STATE OF RHODE ISLAND AND PROVIDENCE PLANTATIONS
COASTAL RESOURCES MANAGEMENT COUNCIL
INTER-OFFICE MEMORANDUM

DATE: March 26, 2012

SUBJECT: Staff Report for CRMC File 2011-12-017 - South Kingstown petition for Matunuck shoreline feature designation

1 **Figure 1.** – Town of South Kingstown exhibit submitted as part of its petition filed with the CRMC

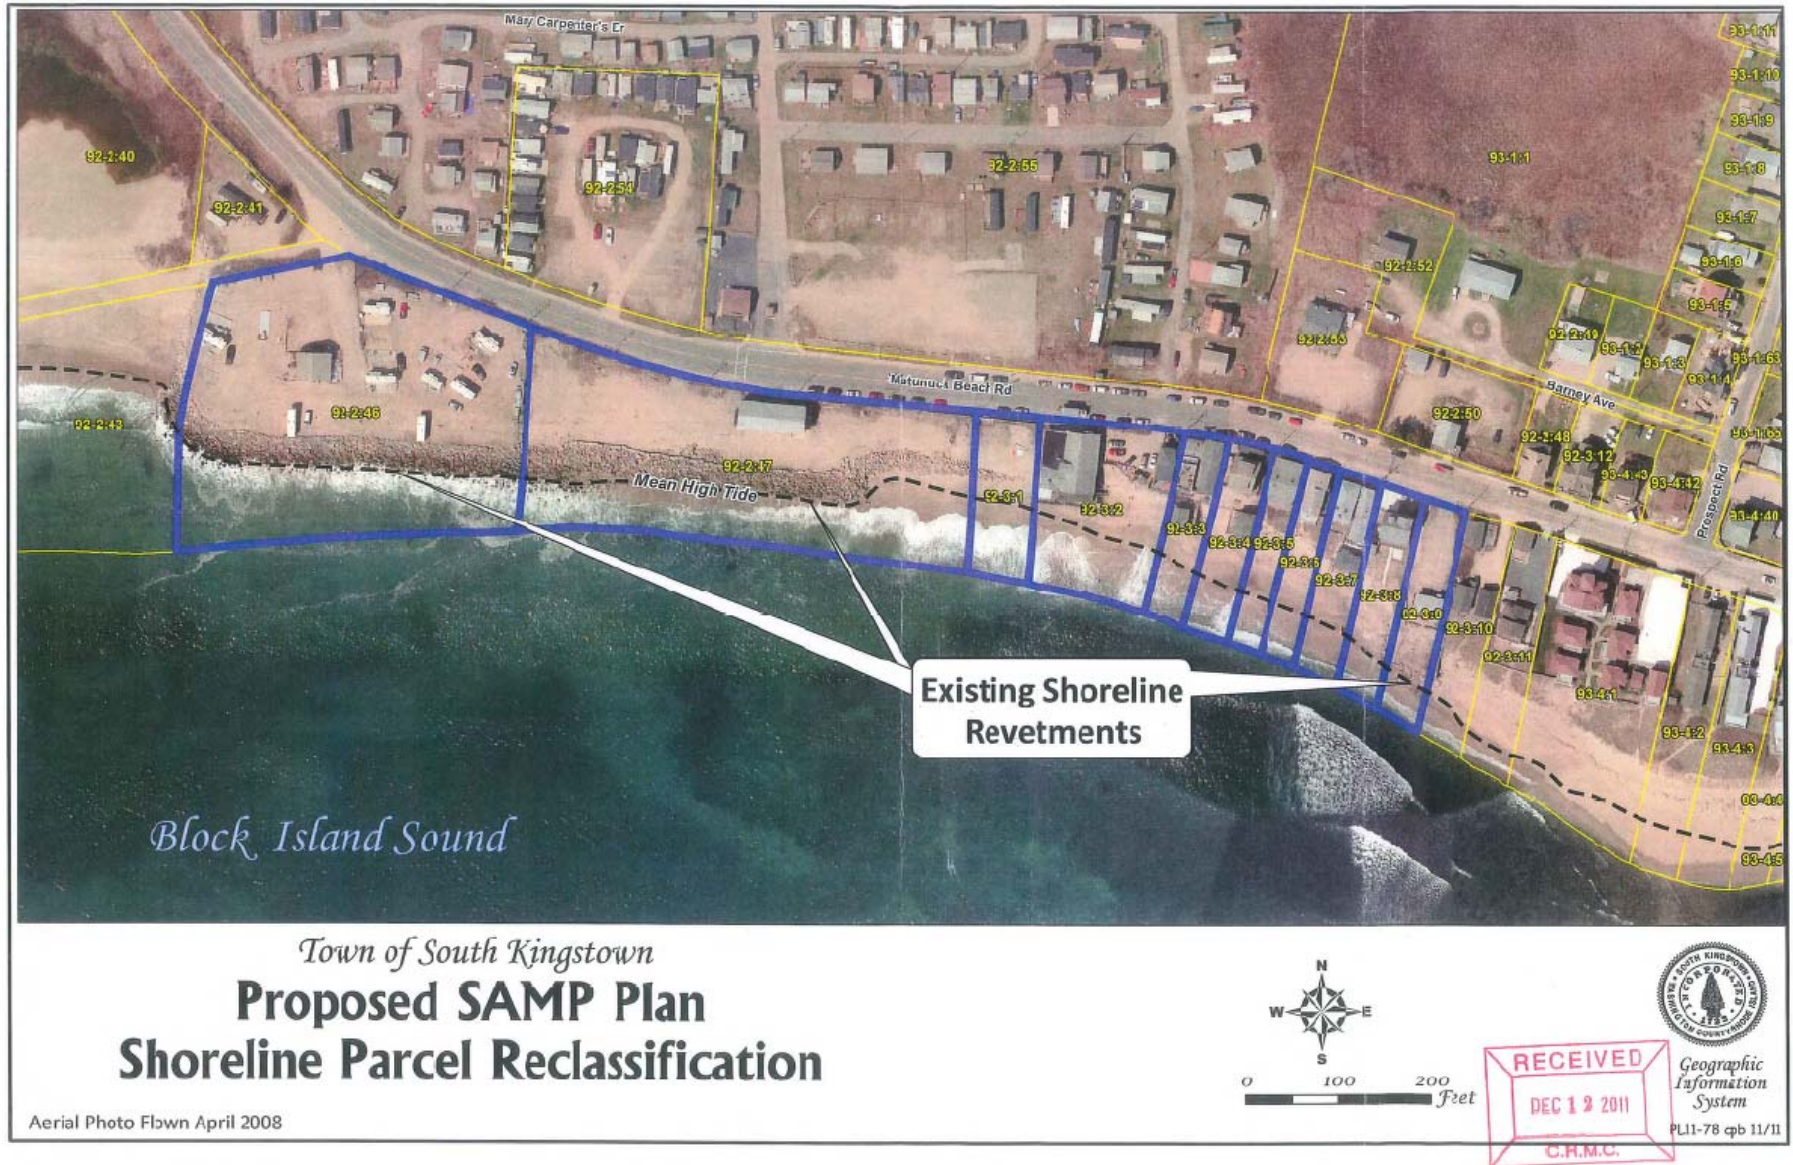
- The Town's petition seeks the Council's determination to affirmatively characterize the petition segment shoreline as a "manmade shoreline" as defined by CRMP Section 210.6; the Town's petition is not a request for a coastal program rule change.

- There are about 1000 feet of existing shoreline protection structures (rip-rap revetments and concrete block walls) that comprise 70 percent of the 1400-foot petition segment, and existing shoreline protection structures are present at both ends of the petition segment.

25 As to whether the present characteristics of the petition segment meet the CRMC definition of
26 manmade shoreline, as defined above, the existing shoreline protection structures occupy more
27 than 70 percent of the shoreline segment, there are structures at both ends of the segment, and
28 there is a relatively short distance (400 feet) between the existing shoreline protection structures.
29 The entire shoreline of the petition segment appears to have been altered to the extent that natural
30 shoreline features are no longer dominant in this location. Further, the petition segment has a
31 concentration of shoreline protection structures. Thus, given the combination of all these factors
32 it is the opinion of CRMC staff that the petition segment can be characterized as a manmade
33 shoreline as defined in CRMP 210.6.
34

35 One Objector described the petition segment as “[t]he shoreline in this area consists almost
36 entirely of beach.” While we do not disagree that there is certainly beach along some portions of
37 the petition segment this shoreline segment in our view has a preponderance of manmade
38 shoreline protection structures. Further, Objectors note that CRMC staff in a memo to the Town
39 dated February 25, 2011 had indicated that the stretch of shoreline in question does not meet the
40 criteria for classification as manmade shoreline. However, the exact language in that memo is
41 “this shoreline does not appear to meet the definition of manmade shoreline.” See CRMC memo
42 at 2. Moreover, the February 2011 assessment was a general characterization of the Matunuck
43 shoreline from the Town beach to Deep Hole. Since that time the Town has identified a specific
44 shoreline segment as depicted in the Town’s exhibit as part of its December 2011 petition

Based on the evidence and facts presented herein it is CRMC staff opinion that the shoreline within the petition segment could be characterized as a manmade shoreline as defined in CRMP 210.6. However, since the pending application is a contested case and CRMC staff has not had the opportunity to review and consider new testimony and evidence that will likely be presented at the public hearing, CRMC staff defer to the Council's decision in this matter. Should the Council grant the Petitioner's request a number of stipulations are provided herein that CRMC staff recommend that the Council adopt and include in its final decision in this matter.

25
26 **Figure 2.** CRMC staff proposed revetment construction line consistent with the CRMP.
27

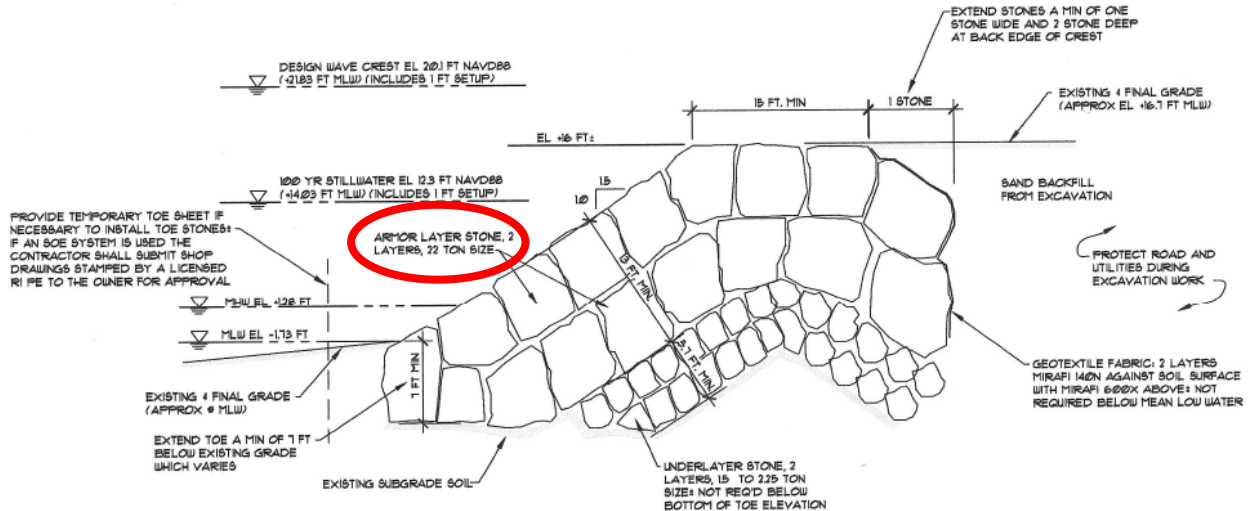
1 other words, the shoreline protection structure cannot be installed farther seaward than specified
2 in Section 300.7.F.1. Additionally, Section 300.7.D.4 prohibits structural shoreline protection
3 when proposed to regain property lost through historical erosion or storm events. Consequently,
4 should the Council approve new structural shoreline protection for the parcels within the petition
5 segment, then the base of the structure will have to be installed as close as practicable to the
6 shoreline feature it is designed to protect (in this case what remains of the eroding bluff) and
7 cannot involve the reclamation of property lost due to historic erosion and storm events. The
8 result will likely be that one or more existing buildings within the petition segment will have to
9 be removed from or repositioned on their respective parcels to meet the design standard specified
10 by Section 300.7.F.1. For example, Hang Ten, LLC, which owns the Ocean Mist building on the

11 left in **Figure 2** below, previously received a CRMC Preliminary Determination (PD) to relocate
12 the existing large building from the left side to the right side of parcel 92-3:2.

13
14 CRMC staff have used this PD proposal to depict the building rotated 90 degrees in order to
15 reduce the seaward extent of the building and allow any proposed revetment to be installed as
16 close to the shoreline feature as practicable in accordance with the requirement of Section
17 300.7.F.1. Furthermore, CRMC staff have proposed a construction line for any proposed
18 revetment that would be reasonably compliant with Section 300.7.F.1 as shown in **Figure 2**
19 below. Accordingly, CRMC staff recommend that the Council require any future structural
20 shoreline protection to conform to the CRMC staff proposed construction line, which is
21 consistent with CRMP Section 300.7.D.3 and based on the past approvals of the Council for
22 these types of structures. The construction line, however, may need to be adjusted at the time of a
23 complete application being filed with the CRMC depending on the site conditions and further

- 6 7. The proposed new revetment shall be installed along the **construction line** identified by
7 CRMC staff as shown in **Figure 2**. The construction line, however, may need to be
8 adjusted depending on site conditions at the time of a complete application filing with the
9 CRMC.

Figure 4. CRMC staff proposed Matunuck Headland Coastal Natural Area.

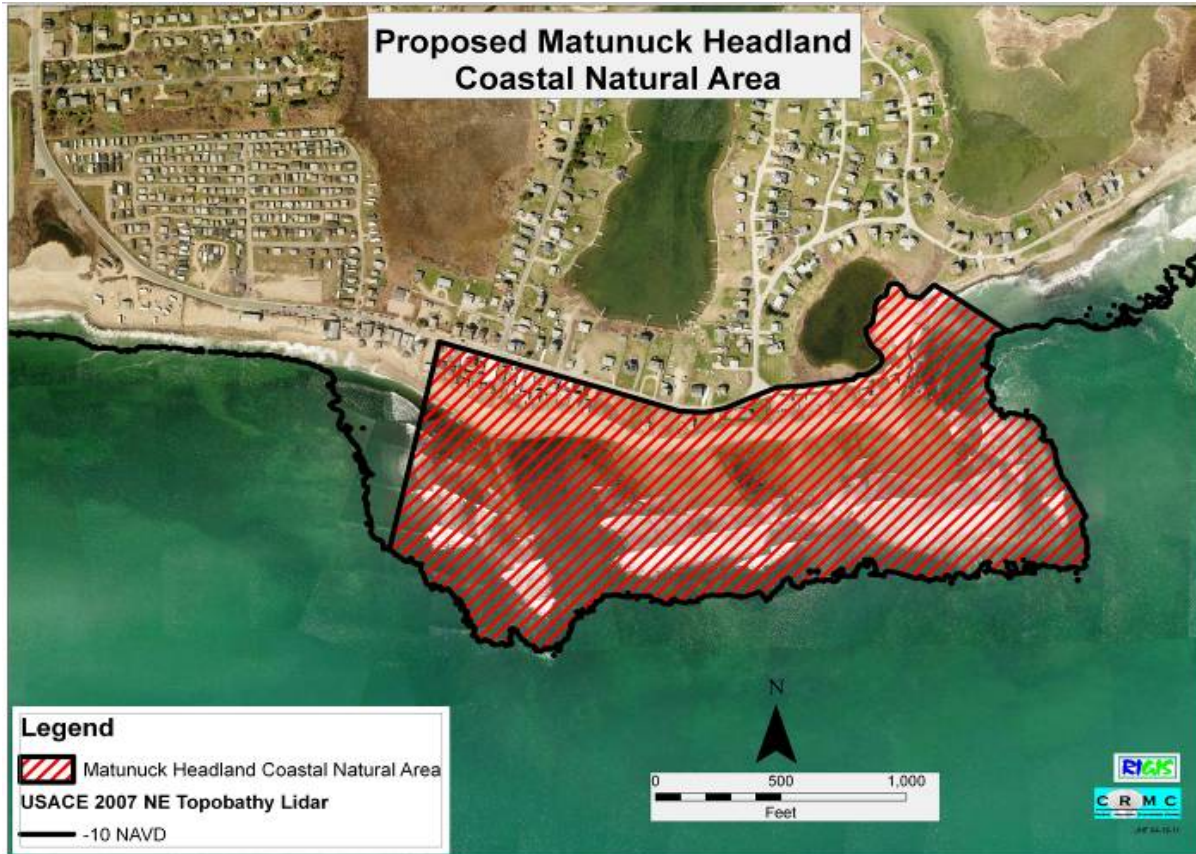
28 First and foremost, CRMC staff recommends that the Council designate a “Matunuck Headland
29 Coastal Natural Area” for the shoreline segment area located between the petition segment and
30 the end of Matunuck Beach Road to include the Deep Hole recreational area, as depicted in
31 **Figure 4** below. This proposed Matunuck Headland Coastal Natural Area would preserve the
32 many existing recreational uses and natural coastal features as described in the April 2011
33 CRMC staff report. The geologic features of this area, namely the shallow, near-shore cobble
34 terrace, help to protect the existing residential buildings and roadway along this segment of
35 shoreline from potentially damaging waves as described in the April 2011 CRMC staff report. It
36 is recommended that this designation of the Matunuck Headland Coastal Natural Area be
37 achieved through a regulatory amendment to the Salt Pond Region Special Area Management

10 The Council’s adoption of the CRMC staff-proposed Matunuck Headland Coastal Natural Area
11 would ensure that the headland beach and dune area along this shoreline segment remain
12 unaltered and that their current functions are preserved so that they can continue to protect
13 abutting upland area without resorting to the use of shoreline protection structures. Moreover, by
14 adopting the proposed coastal natural area, the Council would be fulfilling its statutory mandate
15 of balancing competing uses of the shoreline and preserving and restoring the coastal resources
16 of the state, as articulated in R.I.G.L. § 46-23. The Council’s designation of the petition segment
17 as a man-made shoreline, accompanied by the designation of the proposed coastal natural area
18 would be consistent with and supportive of the Council’s policy to “balance multiple uses of the
19 region, while preserving and, where possible, restoring the environmental quality.” See RICRMP

- 26 1. The CRMC staff proposed **Matunuck Headland Coastal Natural Area** shall be
27 designated and adopted by the Council through a coastal program amendment. CRMC
28 staff will prepare the amendment for the rule-making process if so directed by the
29 Council.
